**Re: Fremont Apartment Project Design Revisions**

# fremont place

2018-04-11  
proposed design revisions

previously approved design (plan view):

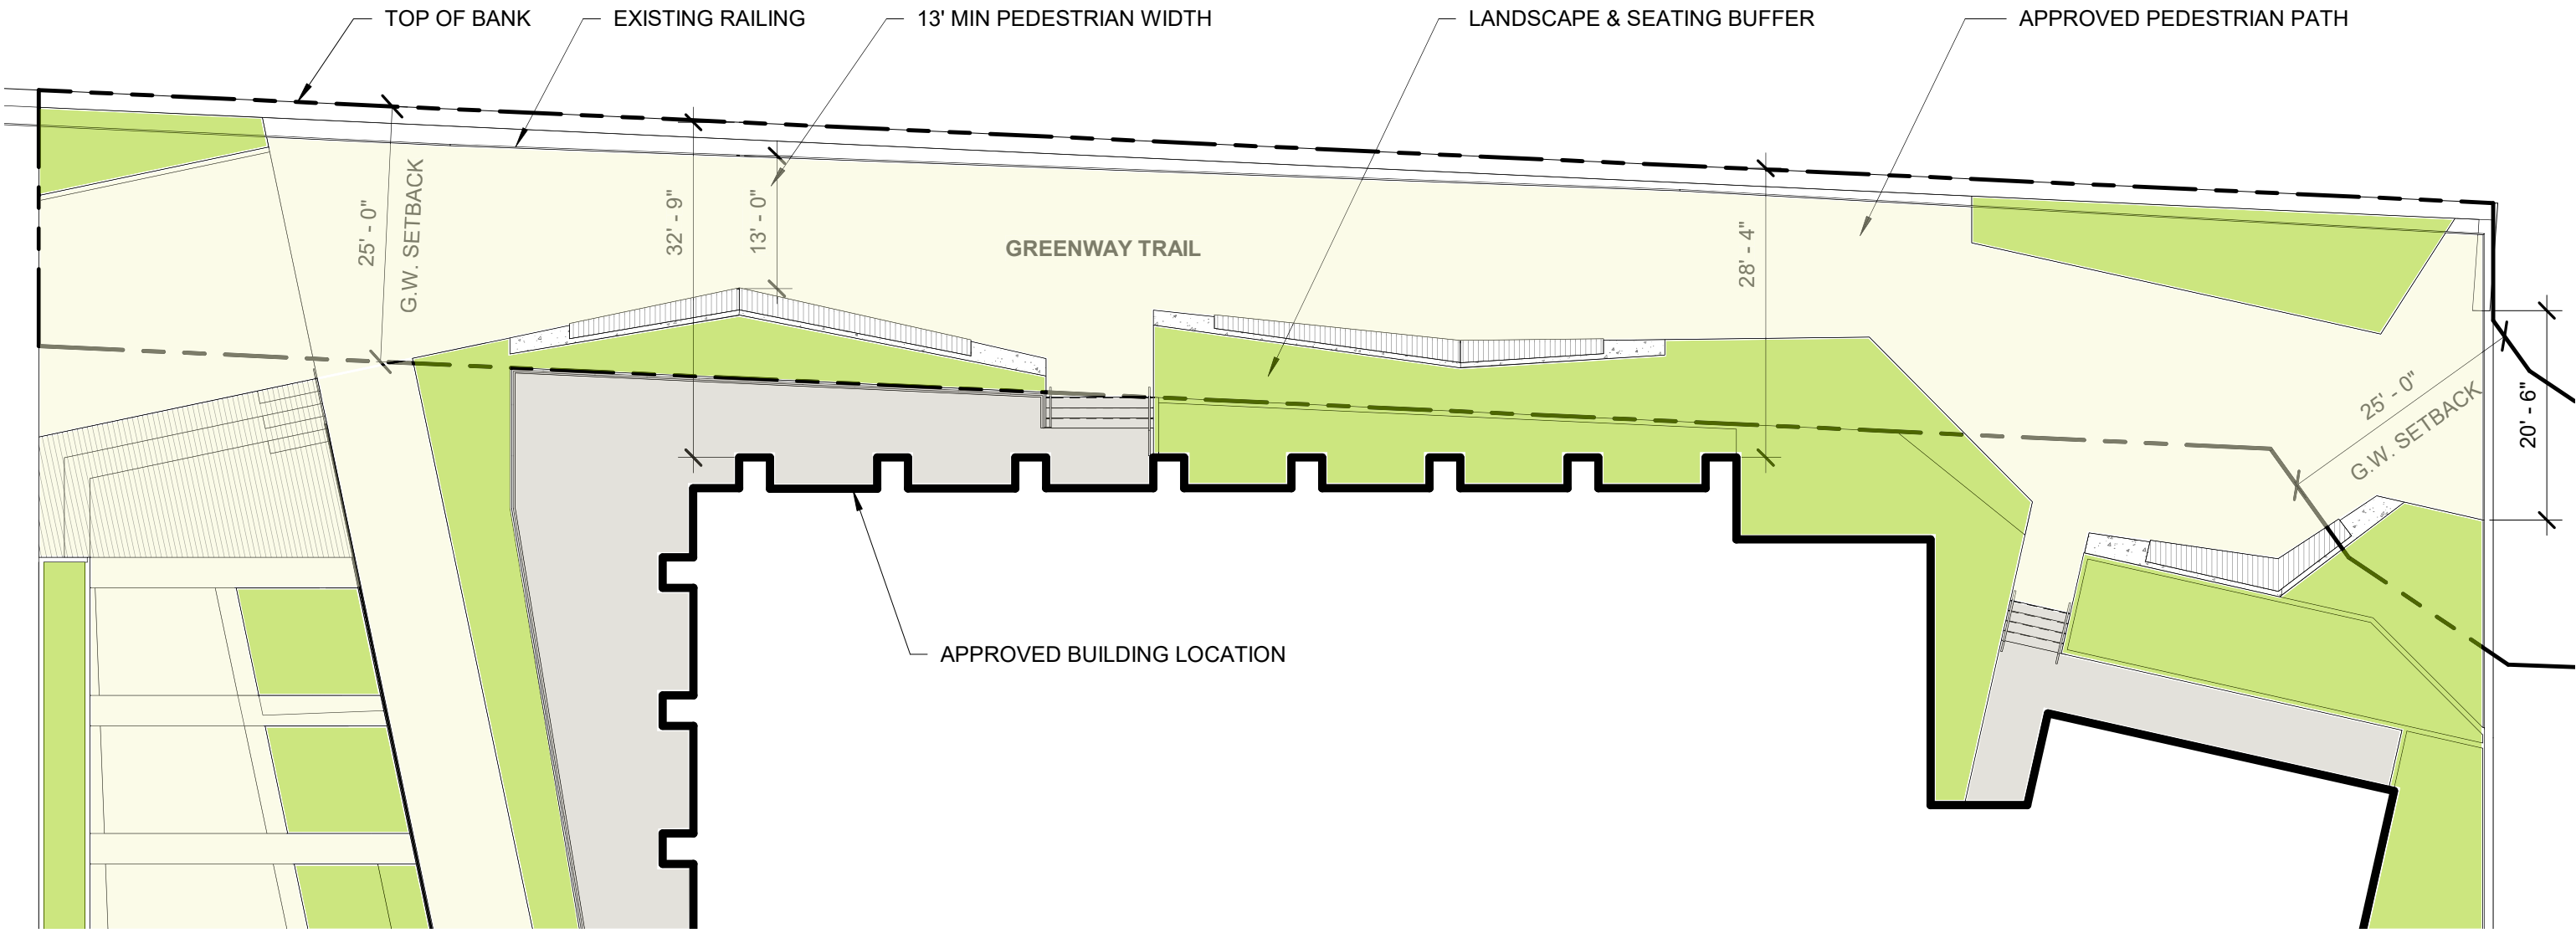
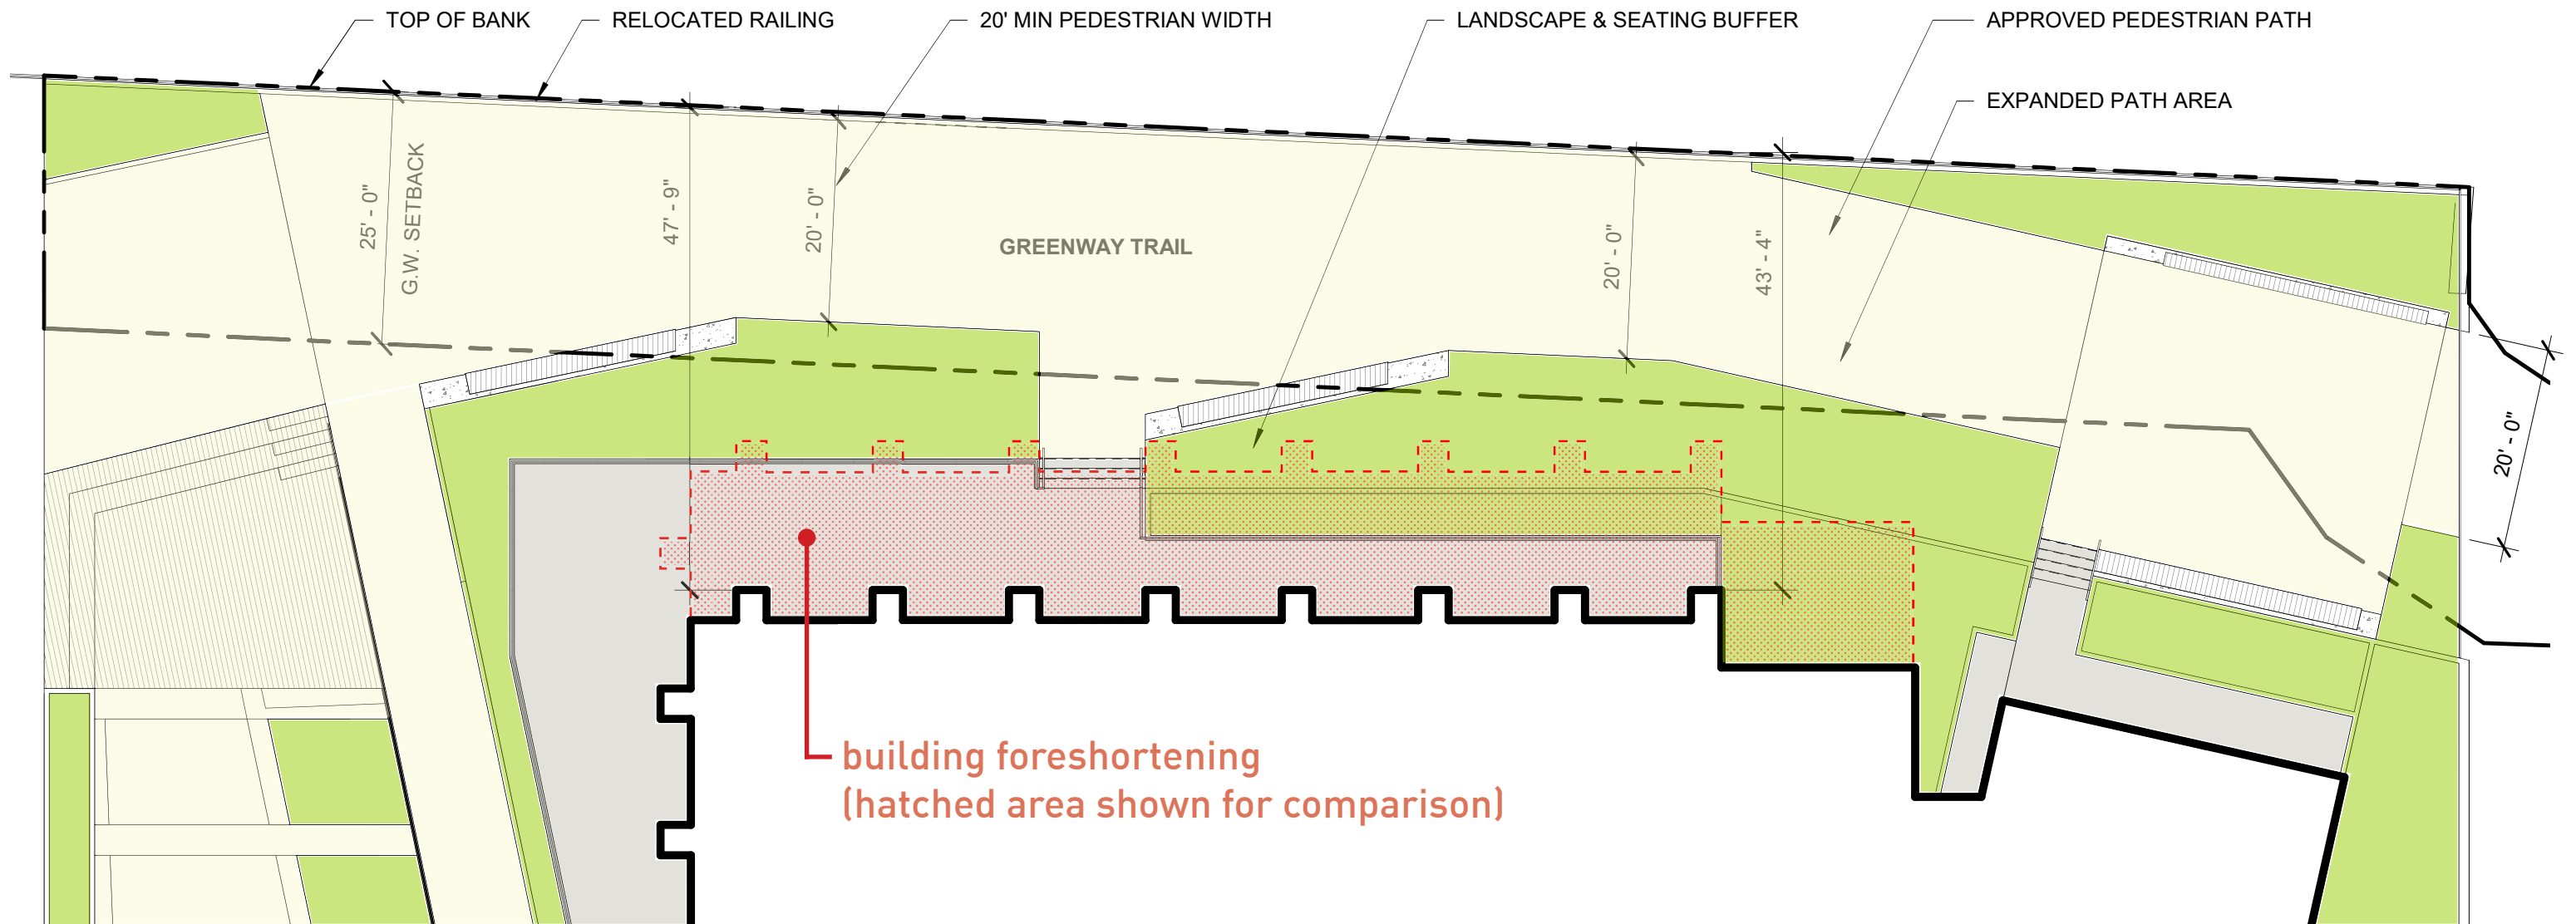
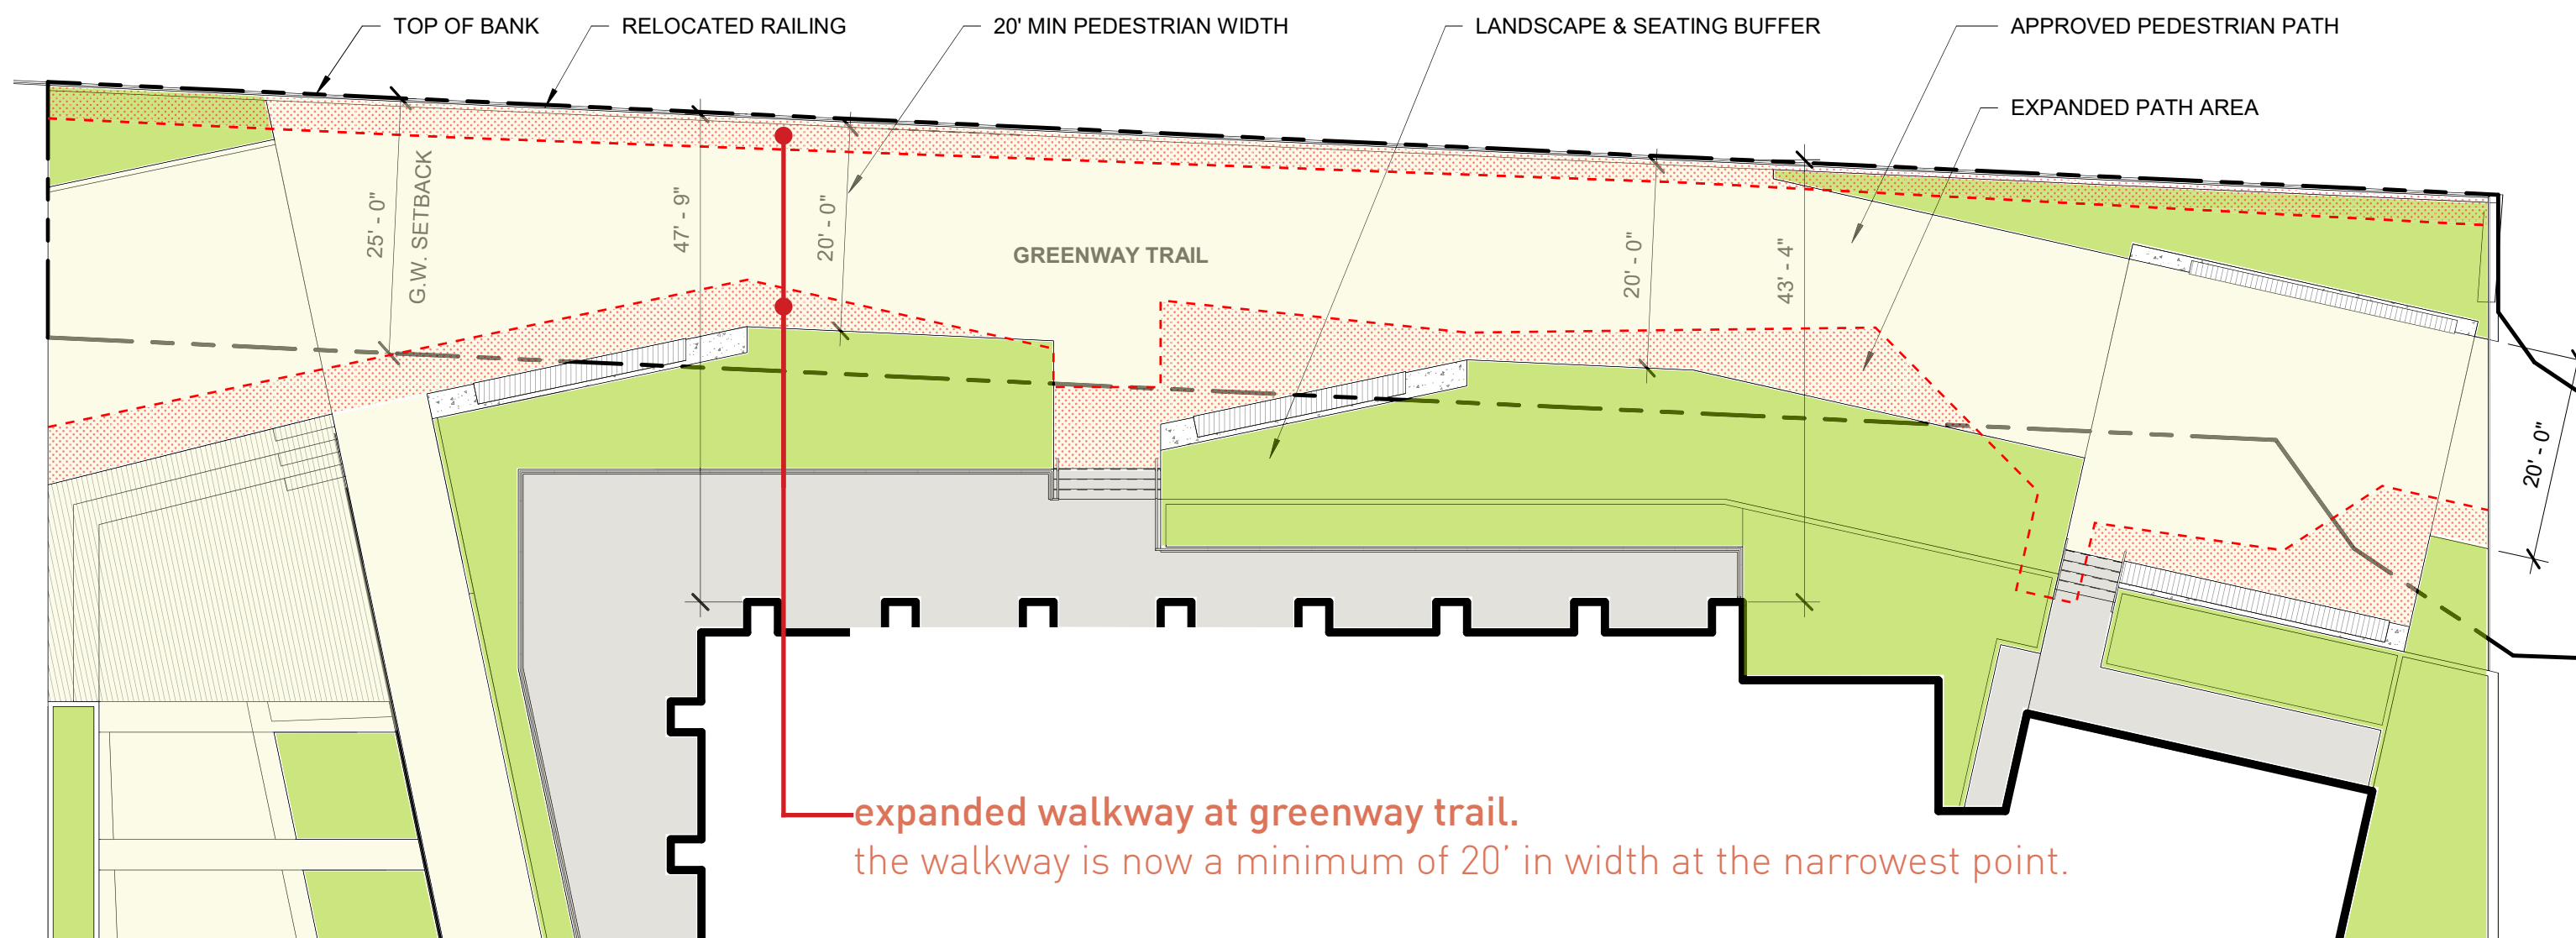
the proposed design changes will provide a paved width of 20' minimum. this dimension exceeds all of the recent development to the north of the Fremont Bridge
